Department of  
Building and Housing  
*Te Tari Kaupapa Whare*

Please find enclosed Errata 1, effective 30 April 2012, to the Verification Method C/VM2, Framework for Fire Safety Design.

<b>Section</b>	<b>Old C/VM2</b>	<b>April 2012 Errata to C/VM2</b>
Status page	Remove page 3/4	Replace with new page 3/4
C/VM2	Remove pages 11-14, 19/20, 31/32, 39/40, 59/60	Replace with new pages 11-14, 19/20, 31/32, 39/40, 59/60

Figure 1.1 a): The design process for C/VM2

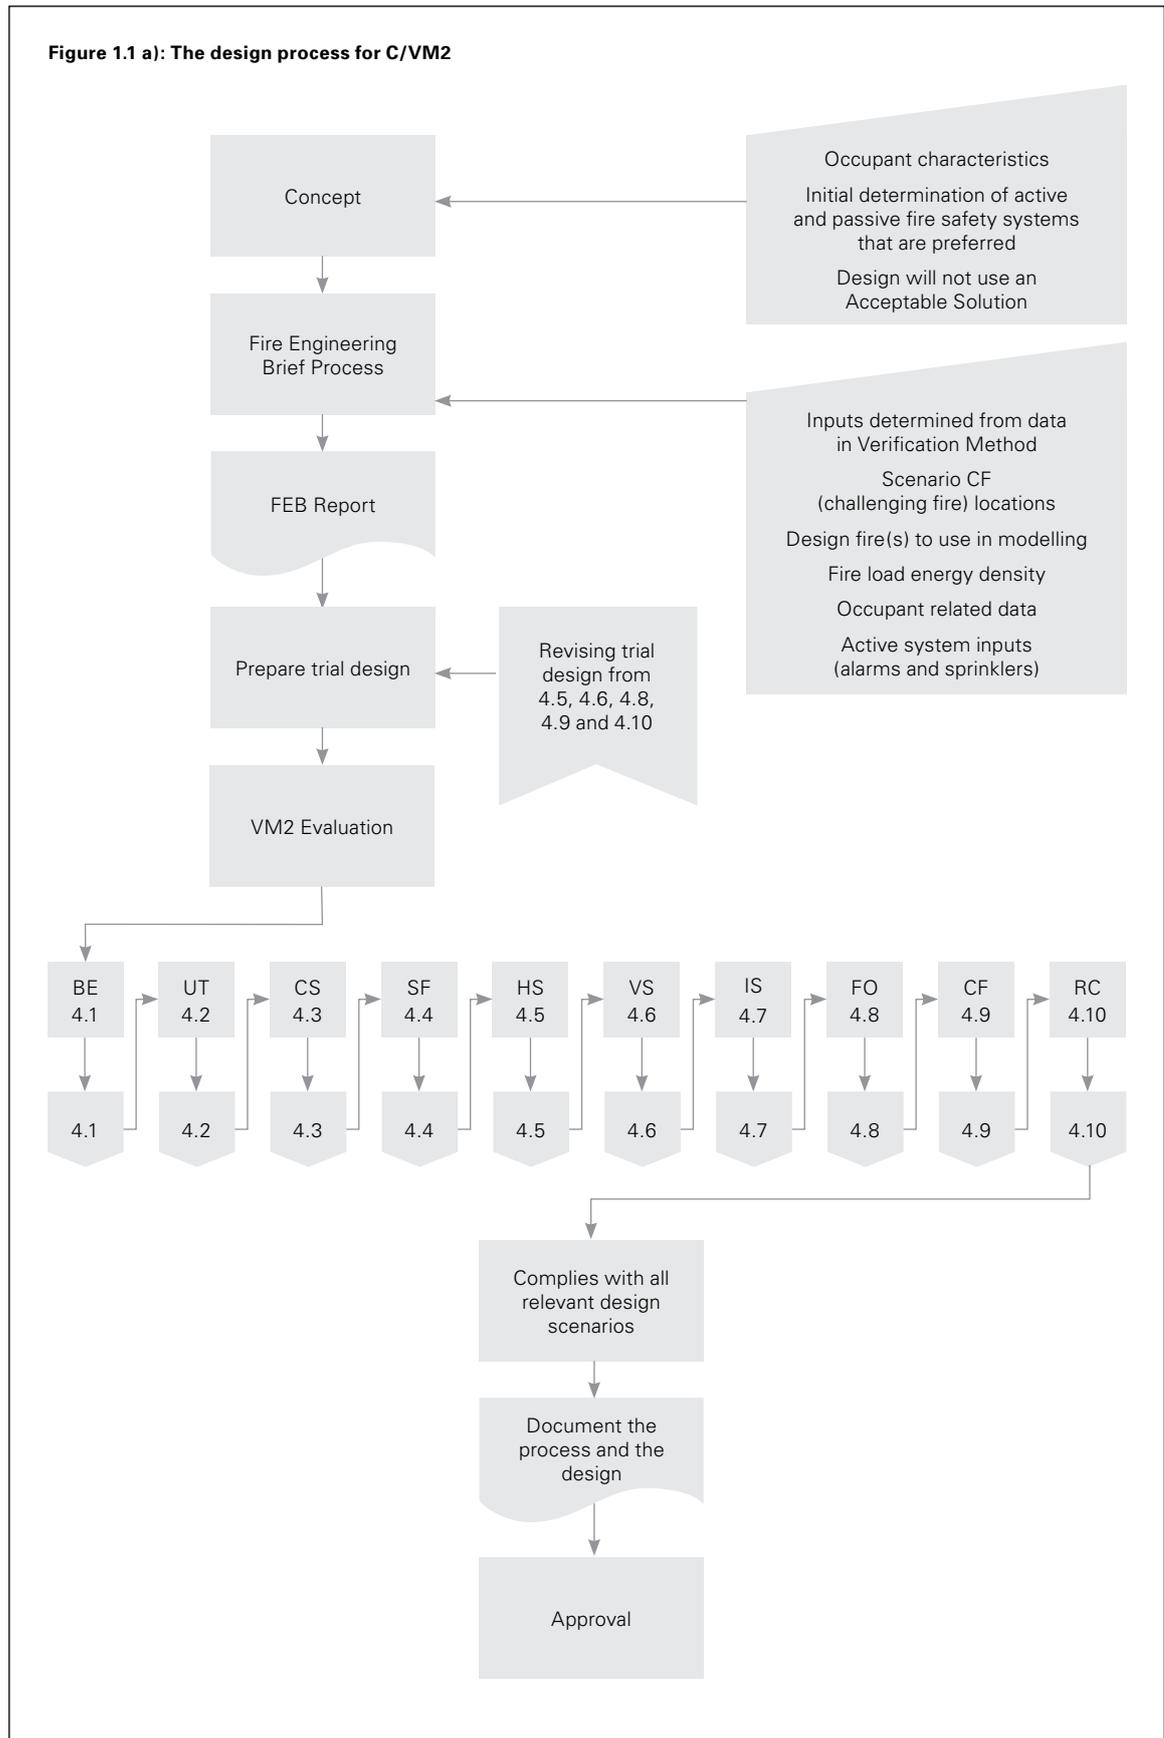
<table><tr> <td>p. 11, 1.2</td> <td>p. 32, Table 2.3</td> </tr><tr> <td>p. 13, Figure 1.1 a)</td> <td>p. 39, Table 3.3</td> </tr></table>

Errata 1  
Apr 2012
